Product / Process Change Notification (PCN)

PCN #: PCN_FeSTAR-GAP_20200520

Affected Series: WE-STAR-TEC Series
74271633; 74271633S

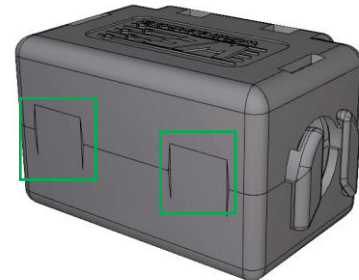
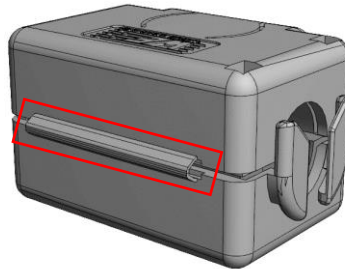
In order to increase the product quality and production capability Würth Elektronik will improve the design of the plastic housing only. Additional the mechanical dimensions will be adjusted and the tolerance type will change from "typ." to "±" tolerances and the packaging specification will be added to the data sheet.

Mechanical Improvement	Before change	After Change
Gap Element		
	The Gap Element design and position will change for an improved assembly process of ferrite core and plastic housing.	
Cable Fixation Elements		
	Both Cable Fixation Elements will be positioned on the same side of the plastic housing to improve the assembly process of the cable.	
Snap-In Mechanism		
	The Snap-In Mechanism will be changed to the proven design of the WE-STAR-BUENO Series with visual lock windows to check if the part is locked correctly.

The **Hinge** will be changed to the proven design of the WE-STAR-TEC Series, from one solid to two separated hinges.

- The general visual appearance of the plastic housing like WE Logo, design elements and edges will be improved a little bit as it can be seen in the drawings above and below.
- The mechanical dimensions will be adjusted (solid lines) and the tolerances will be changed from “typ.” to “±” (dotted lines).
